Errata

ADS1274EVM-PDK / ADS1278EVM-PDK (PCB Revision F)

Figure 1. Highlighting Affected DIP Switch

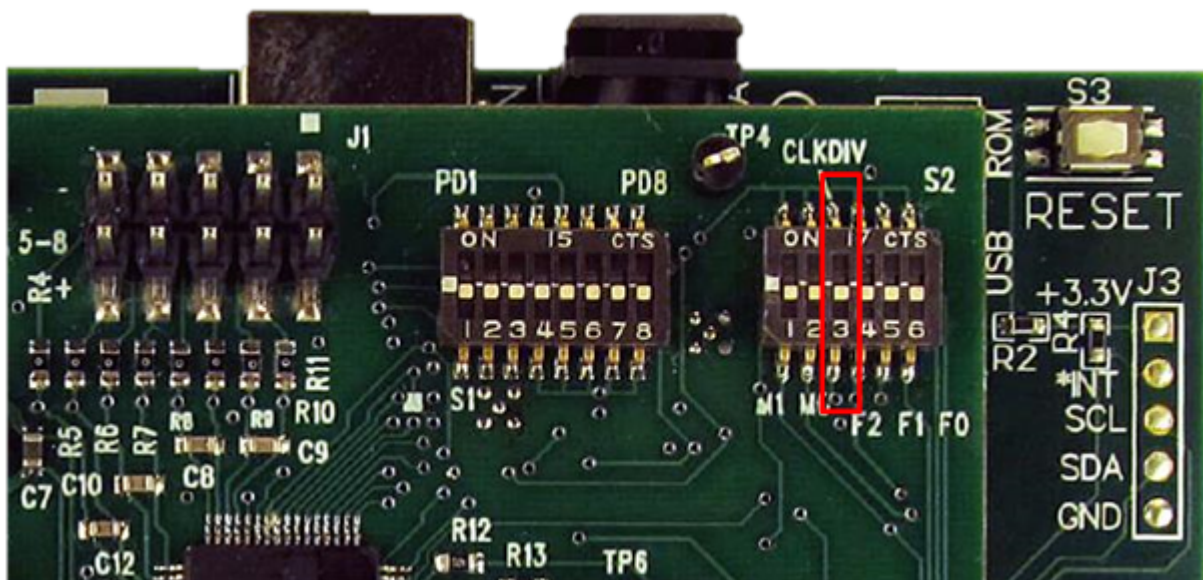
Affected EVMs	ADS1274EVM-PDK, PCB Rev F, BOM Rev E ADS1278EVM-PDK, PCB Rev F, BOM Rev E
Problem Description:	Pin 3 of DIP switch S2 is permanently shorted to the GND plane. This pin drives the CLKDIV pin on the ADS1274/8. CLKDIV is a digital input that sets the modulator frequency for the device.
Affected Modes of Operation:	Low-Speed Mode Low-Power Mode High-Resolution Mode
Low-Speed Mode:	In Low-Speed Mode, CLKDIV = 0 is a supported configuration and the device will perform as expected in this mode. The user will not be able to change CLKDIV to 1 using neither the GUI nor the DIP switch S2. The GUI software will still allow the user to select CLKDIV = 1, but the hardware will not reflect this setting. Therefore, the master clock frequency has to be limited to 5.4 MHz using the PLL setting in the GUI or by an external clock.
Low-Power Mode:	In Low-Power Mode, CLKDIV = 0 is a supported configuration and the device will perform as expected in this mode. The user will not be able to change CLKDIV to 1 using neither the GUI nor the DIP switch S2. The GUI software will still allow the user to select CLKDIV = 1, but the hardware will not reflect this setting. Therefore, the master clock frequency has to be limited to 13.5 MHz using the PLL setting in the GUI or by an external clock.

High-Resolution Mode:	In High-Resolution Mode, CLKDIV = 0 is not a supported configuration of the device. The device performance cannot be evaluated in this mode using this EVM revision.
